# BANG NOISE HEARD AND/OR BUMP FELT FROM FRONT OF VEHICLE DURING A QUICK 1-2 AND/OR 2-3 SHIFT—UNDER MODERATE TO AGGRESSIVE ACCELERATION

TSB 13-6-10

**FORD:**  
2013 Focus

Figure 1 - Article 13-6-10

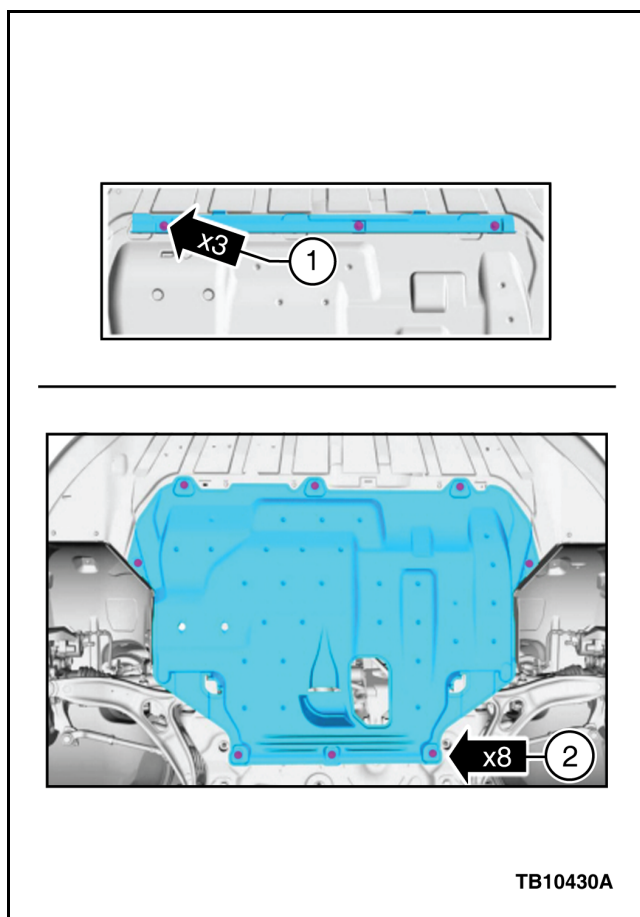
1. Raise the vehicle on a hoist. Refer to Workshop Manual (WSM), Section 100-02.
2. Remove the lower air deflector by removing the three (3) fasteners. (Figure 1)
3. Remove the engine compartment splash shield by removing the eight (8) fasteners. (Figure 1)
4. Lower the vehicle.
5. Remove battery and battery tray. Refer to WSM, Section 414-01.
6. Position hydraulic floor jack with a wood block under transmission and raise only enough to support weight of transmission.
  - a. Do not attempt to lift the transmission or damage will occur.

Figure 2 - Article 13-6-10

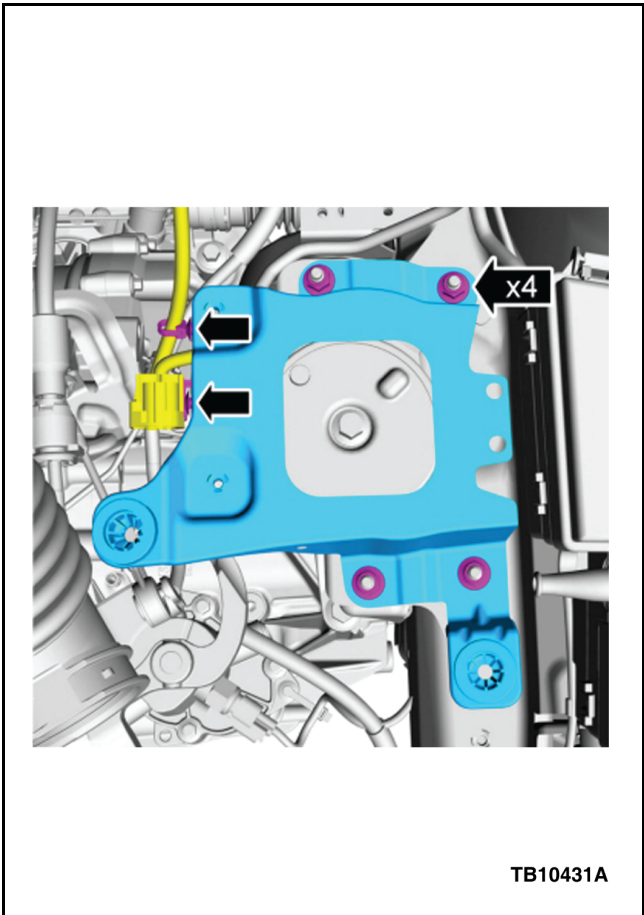
7. Remove battery tray reinforcement by removing the four (4) fasteners. (Figure 2)

Figure 3 - Article 13-6-10

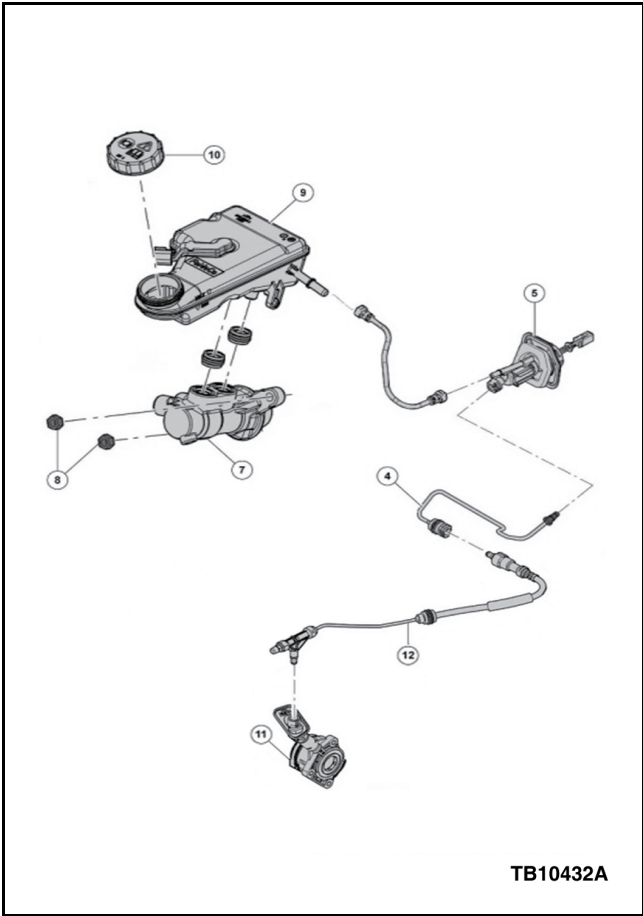
- 8. Remove and discard the center fastener securing the transmission support insulator and remove the insulator.
- 9. Install revised service transmission support insulator and torque new center fastener to 148 N•m (109 lb-ft).
- 10. Replace the clutch slave cylinder hydraulic tube with revised service part. (Figure 3 - Item 12)
- 11. Bleed the clutch system. Refer to WSM, Section 308-02, general procedures, 6 speed manual transmissions.
- 12. Remove floor jack.
- 13. Install battery tray reinforcement with the four (4) fasteners and torque to 48 N•m (35 lb-ft). (Figure 2)
- 14. Install battery and battery tray, refer to WSM, Section 414-01.
- 15. Replace engine mount with revised service part. Refer to WSM, Section 303-01B
